THE CORPORATION OF THE DISTRICT OF BURNABY

TO: MR. H. W. BALFOUR DEPARTMENT: MUNICIPAL MANAGER DATE: MARCH 4, 1970  
FROM: Planning Director DEPARTMENT: Planning OUR FILE # RZ #63/69  
SUBJECT: REZONING REFERENCE #63/69 YOUR FILE #  
LOTS 1 AND 2 W. 1/2, BLOCK 13, D.L. 158 E. 1/2, PLAN 1908  
PROPOSED C.D. SCHEME

REZONING REFERENCE #63/69

SUBJECT: REZONING REFERENCE #63/69  
LOTS 1 AND 2 W.  $\frac{1}{2}$ , BLOCK 13, D.L.153 E.  $\frac{1}{2}$ , PLAN 1903  
PROPOSED C.D. SCHEME

COMMERCIAL LEVEL PLAN

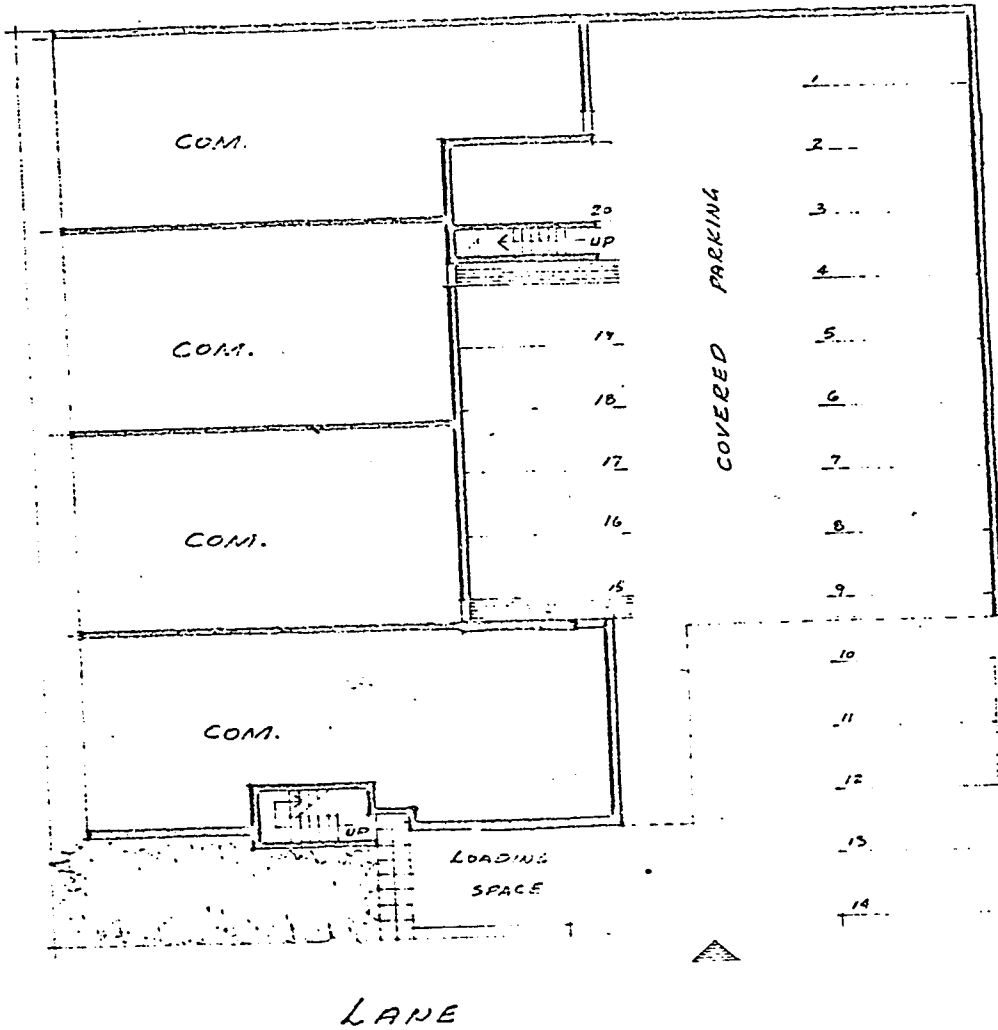
As noted in the Bylaw definition of usable open space, required front yards are excluded as part of the total required usable open space area. Therefore, the deck area which fronts on Neville Street, as noted on the applicant's submittal, could not be considered as complying with the requirements for developed usable open space. This would apply to the required 25-foot front yard setback for the apartment development along the entire frontage on Neville Street. The deck area over the proposed underground parking structure as noted on the Planning Department's proposal would comply with the regulations, i.e. the area is located behind the required front yard, its dimensions are greater than the 20' minimum, and it is available for use by all the tenants (see area outlined in red on attached plans).

SECOND FLOOR DEPARTMENTS

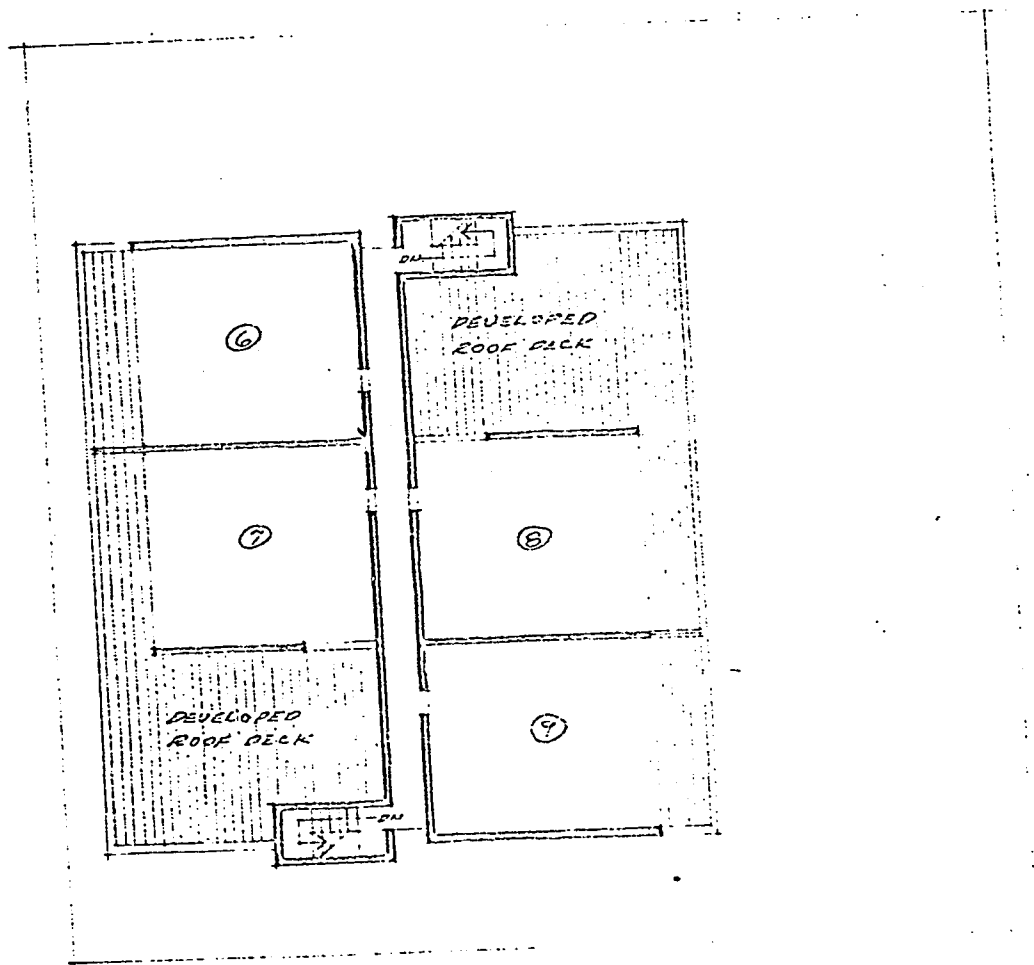
Under this definition, any area intended as part of the required usable open space shall have no dimension less than 20 feet. Therefore, the minimum space that could comply with the regulations would be an area of 20' X 20'. With reference to the applicant's proposal, none of the balconies or deck areas on the top floor comply with this requirement. Balconies have never been included as part of the required usable open space for any apartment development. Furthermore, roof decks have never been included as part of the required open space, except in the case of RM5 high density apartment categories.
